6.0 ADMINISTRATIVE CONTROLS

8801050144 871230
PDR ADDCK 05000400
P PDR

FIGURE 6.2-1
OFFSITE ORGANIZATION
DELETED

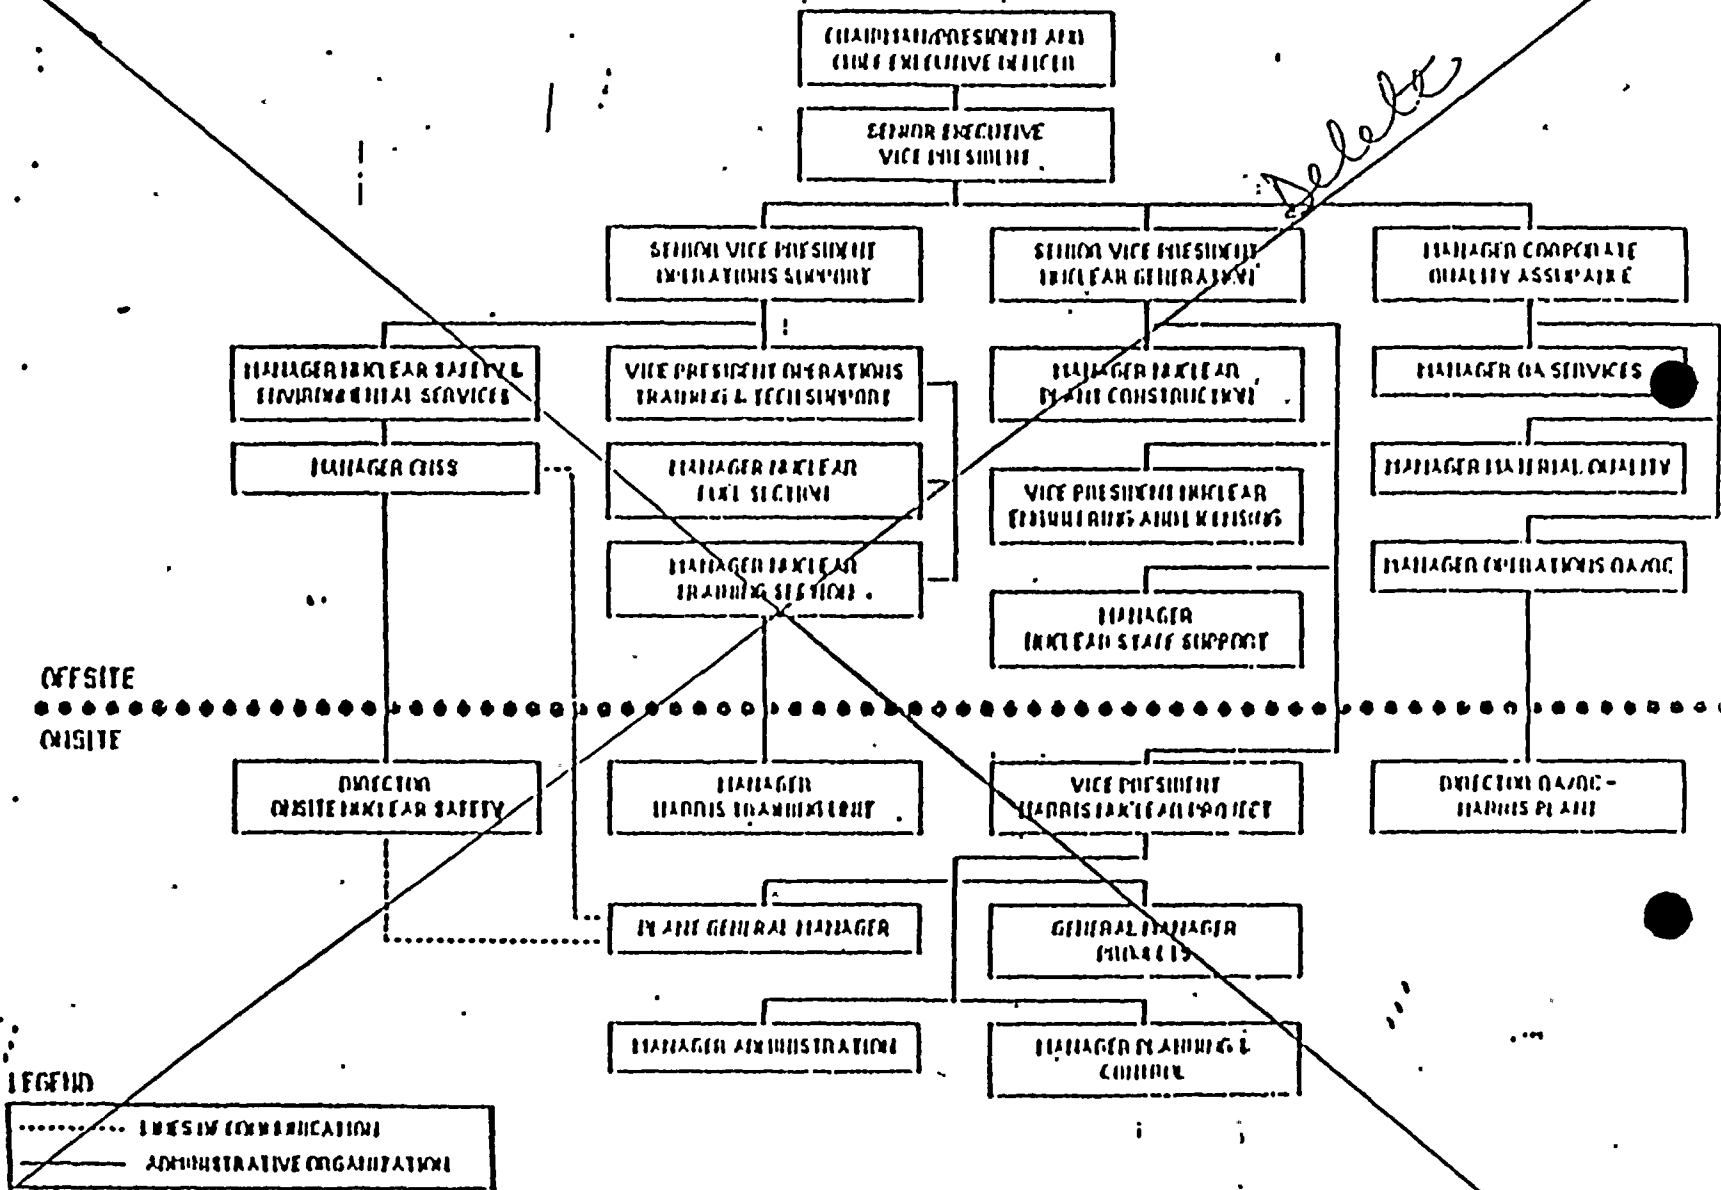
~~6.2.1 The office organization for unit management and technical support shall be as shown in Figure 6.2-1.~~ *(Deleted). Replace with Insert 1 (attached)* →)

Delete

Insert 1

6.2.1 Onsite and Offsite Organization

An onsite and an offsite organization shall be established for unit operation and corporate management. The onsite and offsite organization shall include the positions for activities affecting the safety of the nuclear power plant.

- a. Lines of authority, responsibility and communication shall be established and defined from the highest management levels through intermediate levels to and including all operating organization positions. Those relationships shall be documented and updated, as appropriate, in the form of organizational charts. These organizational charts will be documented in the FSAR and updated in accordance with 10 CFR 50.71(e).
